V8 XJ Series/XK

TECHNICAL BULLETIN

Steering Rack Knocking Or Rattling – Revised Lower Steering Column/Rack Return Line – Repair Procedure

MODEL
1997 MY-ON XK8 Range
1998-2003 MY V8 XJ Series
VIN
001001-ON
812256-F59525

ILLUSTRATION 1

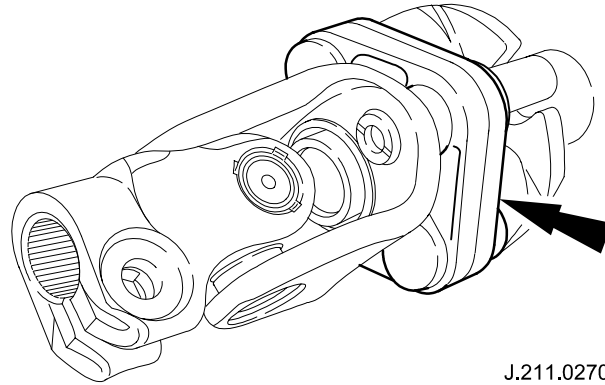
Note: The modified lower steering column has a rubber coupling (Illustration 1). If the modified lower column is present, **continue with PAS line installation only.**

On vehicles prior to VIN A11051 (XK Series) and VIN F20645 (V8 XJ Series), check to see if a modified lower steering column (modified lower steering column has a rubber coupling) has been retrofitted, if not, install a modified lower steering column and new steering rack return line.

POWER STEERING RETURN LINE - XK

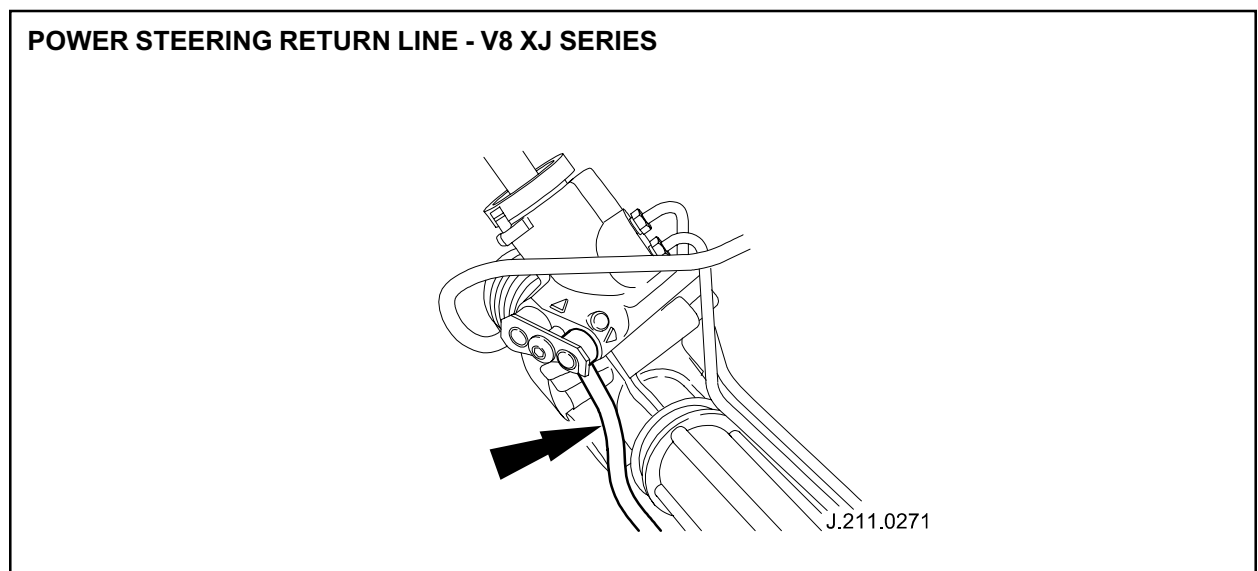
- Install PAS return line (see Workshop Manual, JTIS CD-ROM, section: 211-02, (SRO 57.15.30 for 1997-2000 MY vehicles).

On vehicles after VIN A11051 (XK Series) and VIN F20645 (V8 XJ Series), or if a modified lower column has been retrofitted, install new steering rack return line only.
